Well Name: FEDERAL B COM	Well Location: T30N / R13W / SEC 28 / SESW / 36.779449 / -108.211243	County or Parish/State: SAN JUAN / NM
Well Number: 1	Type of Well: CONVENTIONAL GAS WELL	Allottee or Tribe Name:
Lease Number: NMSF078214	Unit or CA Name:	Unit or CA Number: NMNM73797
US Well Number: 300450913800S1	Operator: DUGAN PRODUCTION CORPORATION

Type of Submission: Notice of Intent	Type of Action: Plug and Abandonment
Date Sundry Submitted: 05/06/2025	Time Sundry Submitted: 01:48
Date proposed operation will begin: 06/02/2025

CONDITIONS OF APPROVAL

Notice of Intent – Plug and Abandonment

Planned P & A Schematic

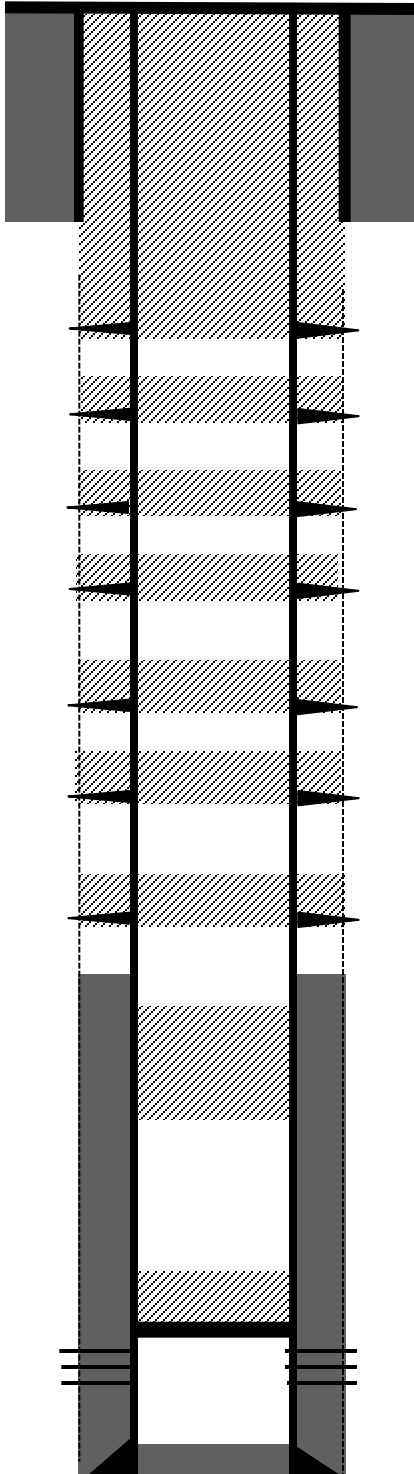
1. Plugging operations authorized are subject to the attached "General Requirements for Permanent Abandonment of Wells on Federal and Indian Lease."
2. The following modifications to your plugging program are to be made:
 - a. Modify Plug 2: Move the TOC to 4250' to account for the BLM geologist's pick for the Mancos at 4350'. Alternatively, each of these formations may be plugged separately.
 - b. Due to the presence of the Animas formation, which possibly contains potable water, combine Plug 8 and the surface plug. Place the BOC at 720' to account for the BLM geologist's pick for the Kirkland formation at 670'.
3. **Notification:** Farmington Office is to be notified at least 24 hours before the plugging operations commence at (505) 564 7750.

-Modify Plug 2: Move the TOC to 4250' to account for the BLM geologist's pick for the Mancos. Alternatively, each of these formations may be plugged separately.

-Due to the presence of the Animas formation, which possibly contains potable water, combine Plug 8 and the surface plug. Place the BOC at 720' to account for the BLM geologist's pick for the Kirtland formation.
